APPENDIX G MITIGATING STRATEGIES ASSESSMENT FOR NEW FLOOD HAZARD INFORMATION ASSESSMENT

G.1 INTRODUCTION

Figure 1 – Mitigation for New Flood Hazard Information and Mitigating Strategies Assessment Flow Chart

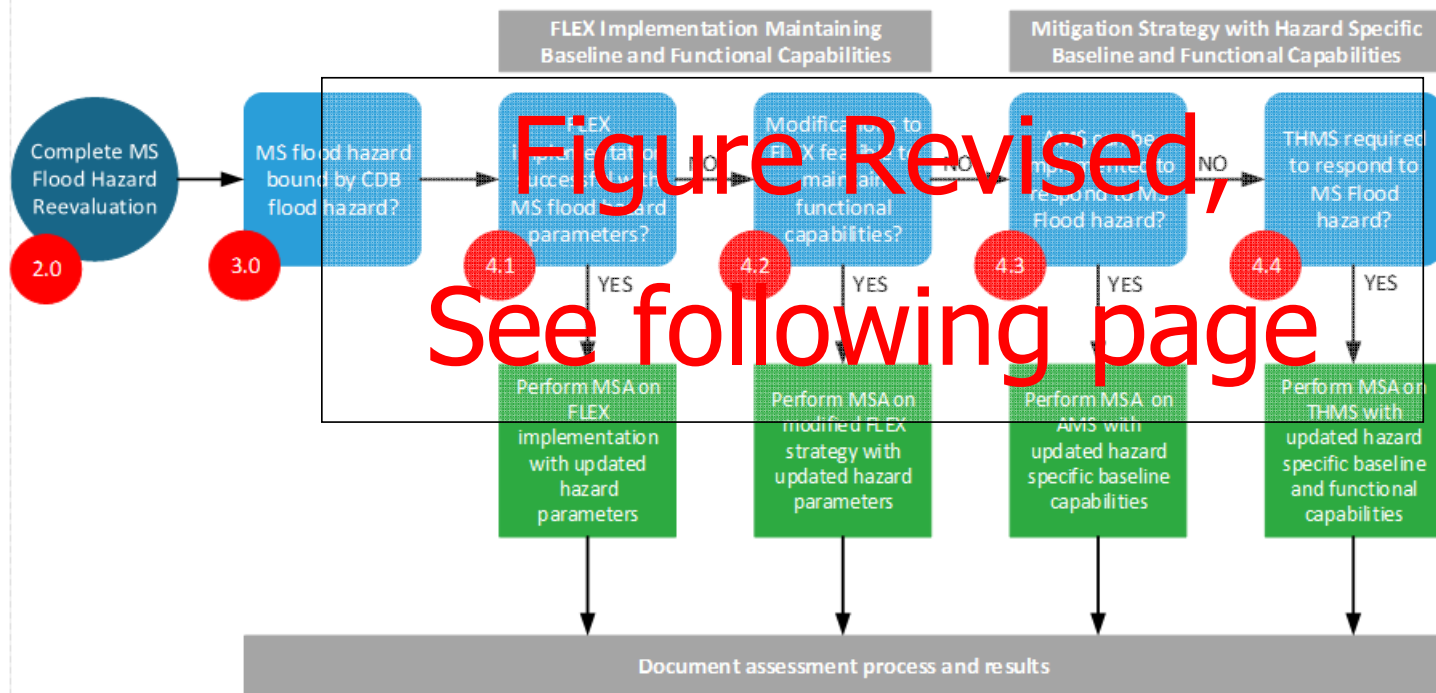
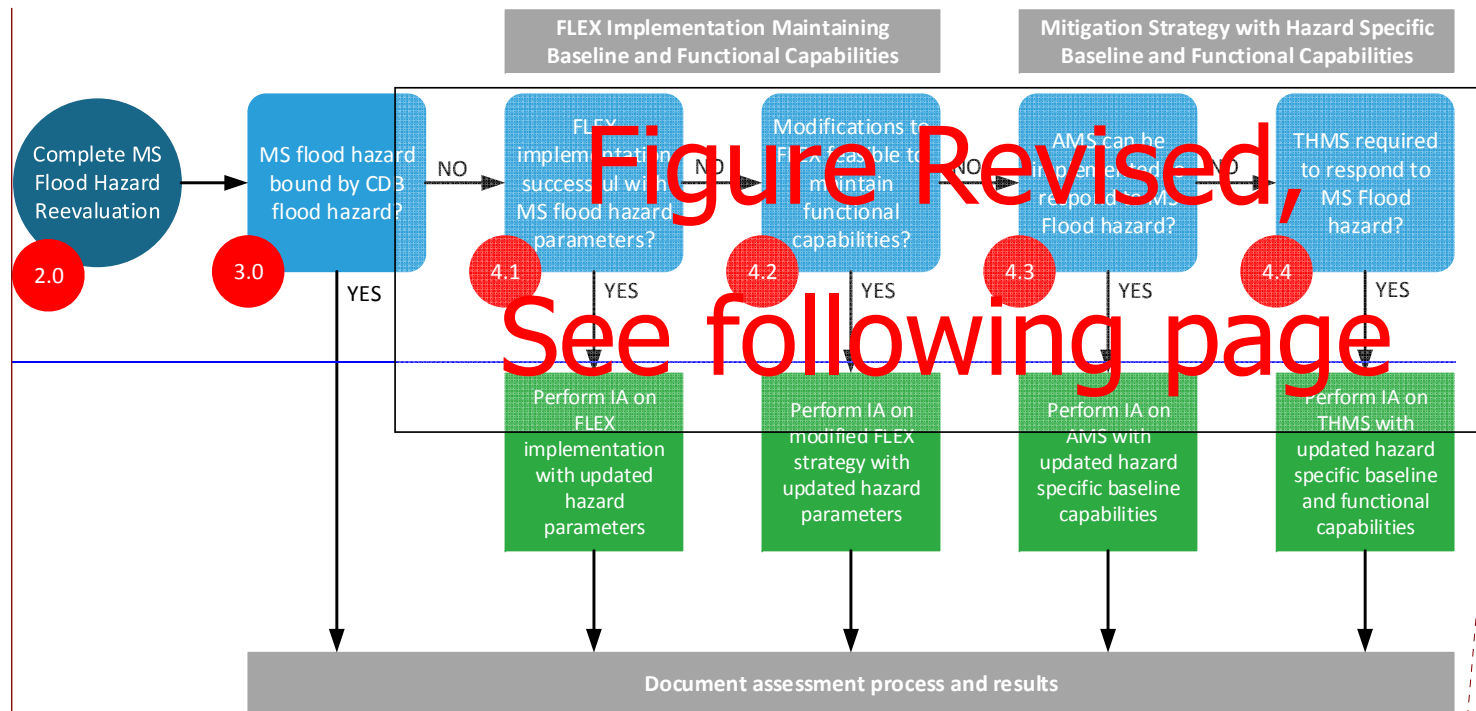
Comment [SSP12]: Use G.x section numbers in the figures.

What about a "Yes" result for the bounded question? Is that not a possible outcome? Show that this would be the MSA or include in this first block.

Comment [NRC13]: The whole lower section of this graph should discuss implementation plans. WRT IAs it should just say "candidate for IA."

Comment [NRC14]: Should this figure include multiple arrows... to reflect evaluation of multiple flooding aspects / hazards?

FFTF – agree, we will add a green block under 3.0 to illustrate the need to document this conclusion.

FFTF - No intent to change – chart is for simplicity not guidance. IA should be removed from the chart. See next page for final chart.

FFTF - No intent to change – chart is for simplicity not guidance. See next page for final chart.

Figure 1- Mitigating Strategies Assessment Flow Chart

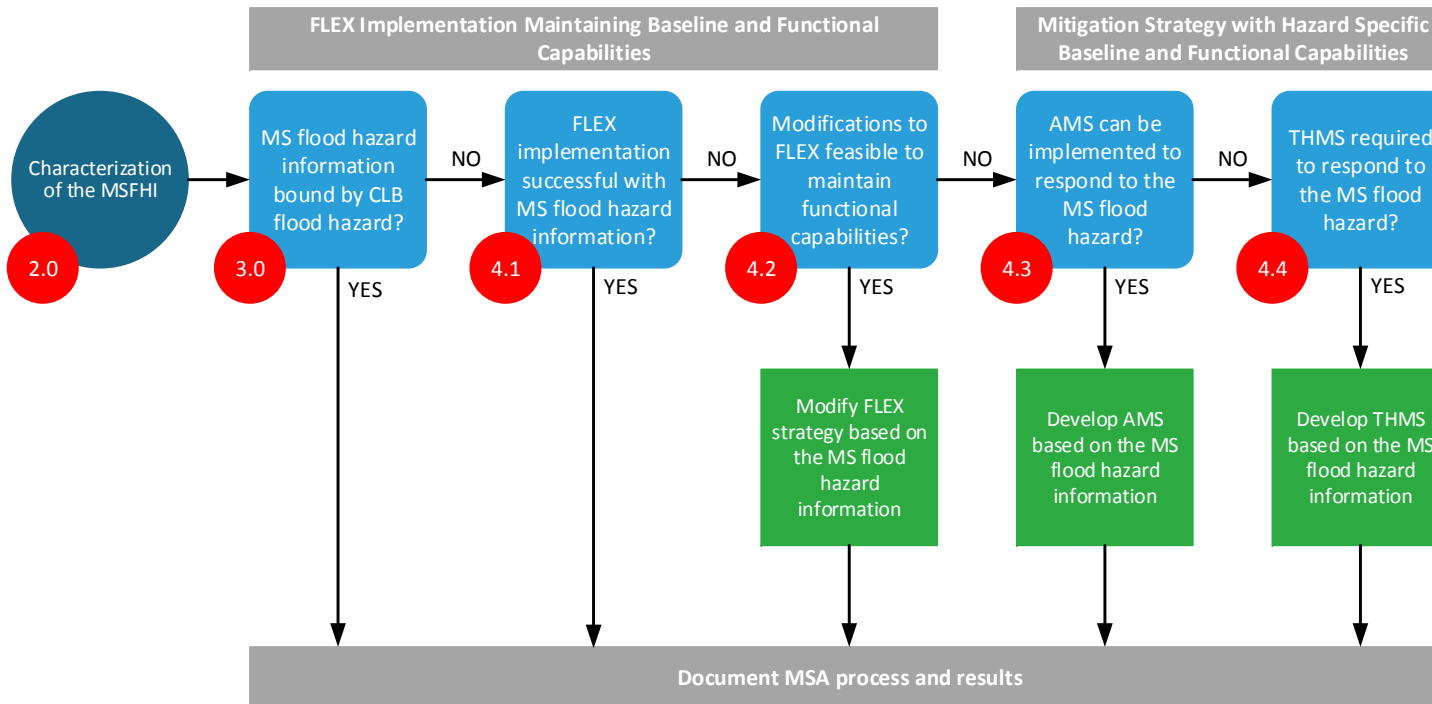
Comment [NRC15]: The whole lower section of this graph should discuss implementation plans. WRT IAs it should just say "candidate for IA."

FFTF - No intent to change – chart is for simplicity not guidance. IA should be removed from the chart. See next page for final chart.

Figure 2 – Alternate Mitigation Strategy Evaluation Flowchart

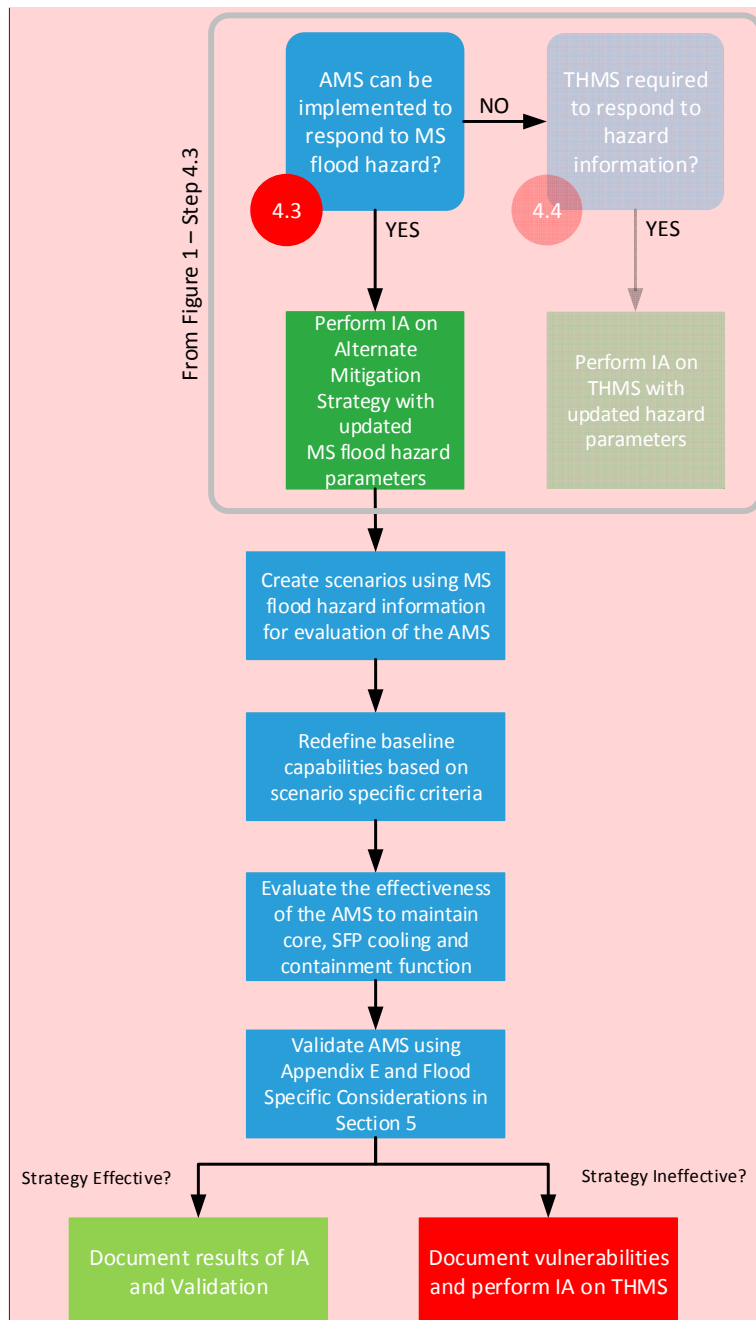
Comment [SSP71]: Change IA to MSA.

Change section numbers and "Step" numbers to G.x, etc...

FFTF _ OK, will change the figure after the rest of the appendix is finalized.

Figure 3 – Targeted Hazard Mitigation Strategy Evaluation Flowchart

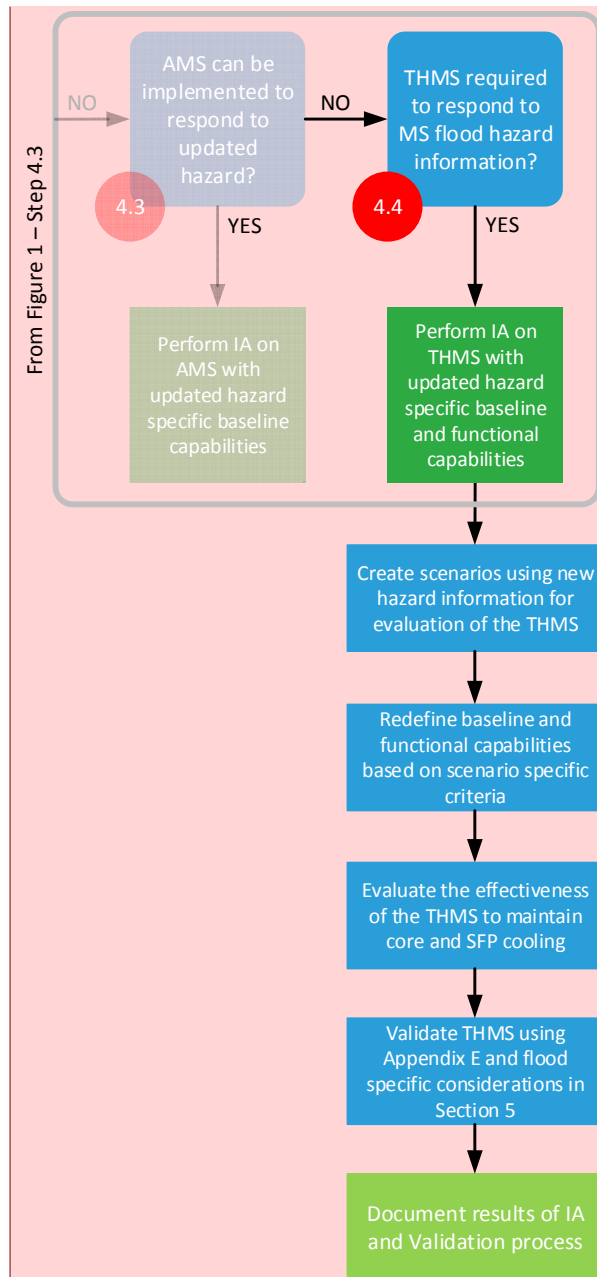
Comment [SSP77]: Change IA to MSA.

FFTF – OK, figures will be revised to be consistent with the final text.
